# Access Compliance Report

## Public Rights-of-Way

### (Curb Ramps)

| Intersection ID: 24051 | Main Street: DEHAVILLAND_DR | Cross Street: SILVER_DART_PL | Location: SW           |

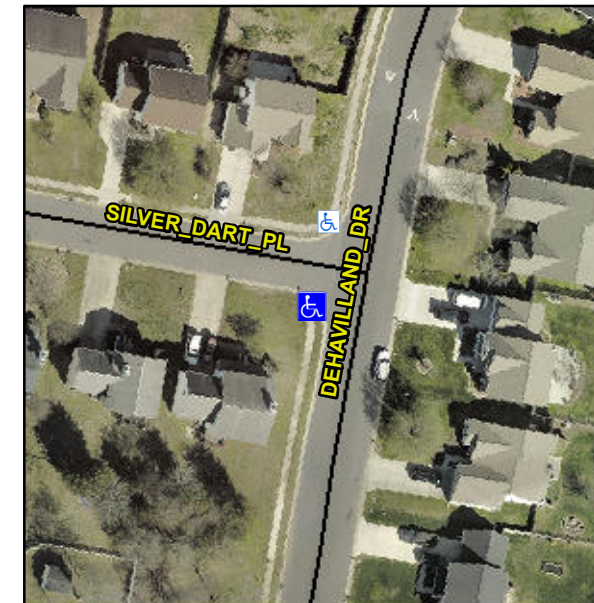
| ADA ID: BC16DEB70B2D   | Ramp Type: PerpDiag         | Initial Pass/Fail: Fail      | Overall Compliance: No |

| Compliance | Description           | Data  | Compliance | Description                 | Data  |
|------------|-----------------------|-------|------------|-----------------------------|-------|
| Yes        | Ramp Width (in)       | 53.0  | No         | Ramp XSlope (%)             | 5.9   |

**Remove & Replace Curb Ramp With Two New Directional Ramps or Equivalent.**

**R304.5.3**
